## NEW MEXICO ENERGY, MINERALS and NATURAL RESOURCES DEPARTMENT

Oil Conservation Division

Administrative application (application reference No. pMES0-501843249) for a non-standard 90.80-acre Pictured Cliffs gas spacing unit comprising Lots 3 and 4 and the E/2 SW/4 (SW/4 quarter equivalent) of Irregular Section 19, Township 30 North, Range 13 West, NMPM, Undesignated Harper Hill-Fruitland Sand Pictured Cliffs Pool (78160), San Juan County, New Mexico, to be dedicated Yates Petroleum Corporation's proposed Vierson Federal Well No. 3 (API No. 30-045-32462), to be drilled at an unorthodox gas well location 1825 feet from the South line and 1520 feet from the West line (Unit K) of Irregular Section 9.

Yates Petroleum Corporation Federal #3 (19-30n-13w)

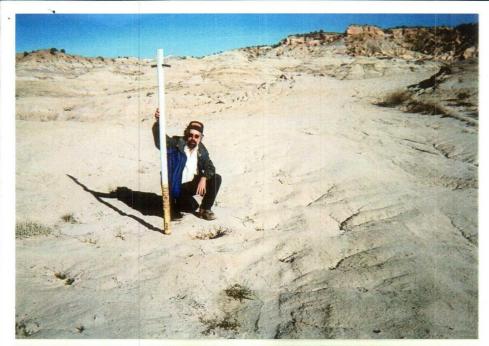
This is a follow-up to my letter dated January 25, 2005 (see copy attached) again requesting information to support this application the Division has determined to be incomplete. So that the Division can properly proceed with reviewing and issuing an order for the proposed unorthodox Pictured Cliffs gas well and resulting non-standard gas spacing unit please provide an adequate explanation as to why Yates can not utilize the old wellsite for and/or road leading to the plugged and abandoned Ladd Petroleum Corporation Butte Well No. 1 (API No. 30-025-09333), located 1060 feet from the South line and 790 feet from the West line (Unit N) of Irregular Section 19 that was plugged and abandoned in 1987?

My review of the Division's records indicate a plugged and abandoned well site approximately 1057 feet southwest of the proposed Vierson Federal Well No. 3, which was the Ladd Petroleum Corporation's Butte Well No. 1 (API No. 30-025-09333) located 1060 feet from the South line and 790 feet from the West line (Unit N) of Irregular Section 9 that was plugged and abandoned in 1987. Why can't Yates utilize this old well site and road to drill its proposed well?

As requested, I inspected Ladd's P&A Butte Well #1 on March 7, 2005. The well was plugged in 1987 and the 1/4 mile long road is blocked. The well site is  $100' \times 150'$  and located on a tear drop shaped badland hill. This is smaller than Yates' staked location of  $130' \times 170'$ .

These limitations have led to a pseudo-karst environment (see pictures). There are numerous sinkholes in the road, one of which is 6' deep. There are more sinkholes on the pad, the two largest of which are 5' deep and 5' to 10' wide. Both of these are within 60' of the P&A marker.

To further complicate matters, Ladd plugged through Yates' target zone of the Pictured Cliffs. Thus, to avoid any possible formation damage, Yates would have to move away from the Ladd well bore. This would require >10' cuts and fills on unstable slopes. BLM is already sufficiently concerned about erosion to require Yates to mulch the staked well site when it is reclaimed.

- 1) Using the Ladd site would result in an unsafe well site
- 2) Using the Ladd site would create more erosion in an erodible environment due to expanding the pad onto steep unstable slopes, laying an extra 1/4 mile of pipeline, and opening an extra 1/4 mile of road
